Work Order ID 92795

Item Name: Crosstube Fwd High

DRAWING NO. D212-664-141	TITLE XTUBE ASSY (205/212/412 HI FWD)	REV. D	DART AEROSPACE LTD ENGINEERING ORDER		D.E.O. NO. D212-664-141-D-1	SHEET NO. SHEET 1 OF 2	SCALE NTS
DRAWN	CHECKED	MFG. APPR.	APPROVED	DE APPR.			
DATE 11.04.07	DATE 11.07.11	DATE 11.04.12	DATE 11/04/12	DATE 11.04.12

DRAWING NO. D212-664-141	TITLE CROSSTUBE ASS'Y (205 HI FWD)	REV. D	DART AEROSPACE LTD ENGINEERING ORDER		D.E.O. NO. D212-664-141-D-2	SHEET NO. SHEET 1 OF 1	SCALE NTS
DRAWN <i>UP</i>	CHECKED <i>ASS</i>	MFG. APPR. <i>AB</i>	APPROVED <i>MP</i>		DE APPR. <i>MP</i>		
DATE 11.07.15	DATE 11.07.20	DATE 11.07.21	DATE 11/07/21		DATE 11.07.21

**D212-664-141/-141B
ASSEMBLY DETAIL**

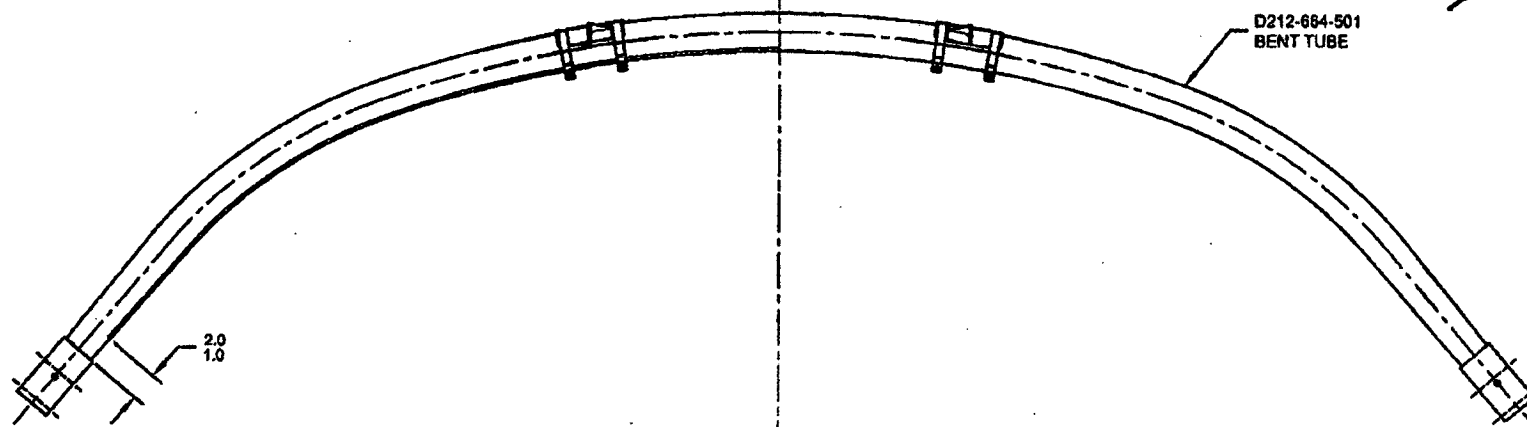
PURPOSE:

ADD AN INSPECTION WINDOW TO UNDERSIDE OF CROSSTUBE.

NOTES 2 OF SHEET 1 IS AMENDED AS FOLLOWS:

- 2) FINISH: CHEMICAL CONVERSION COAT PER DART QSI 005 4.1
PRIME INSIDE AND OUTSIDE PER DART QSI 005 4.2
MASK UNDERSIDE OF CROSSTUBE AS SHOWN (HATCHED AREA) AND
PAINT OUTSIDE PER DART QSI 005 4.2
REMOVE MASKING AND APPLY CLEAR COAT

- 2) FINISH: CHEMICAL CONVERSION COAT PER DART QSI 005 4.1
PRIME INSIDE AND OUTSIDE PER DART QSI 005 4.2
PAINT OUTSIDE PER DART QSI 005 4.2

MASK AREA PRIOR TO PAINTING,
REMOVE MASKING AFTER PAINT
AND APPLY CLEAR COAT
